TO: PARTS MANAGER   
SERVICE MANAGER

92-1

## A. V6 262 CID (4.3L) PARTS INFORMATION

### Connecting Rod Bearings

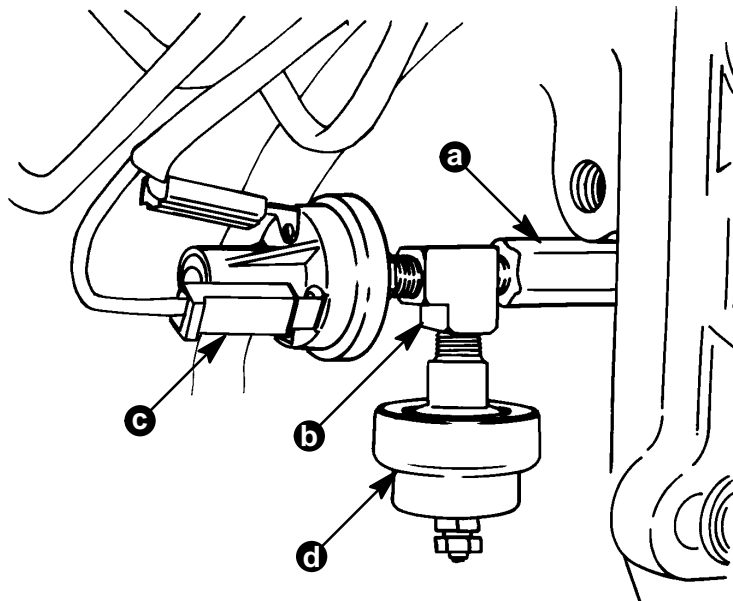
The current parts list shows only 2 size bearings; standard and .001 in. U.S. Two additional U.S. bearings are going to be stocked:

23-811858	.010 in.	U.S.
23-811859	.020 in.	U.S.
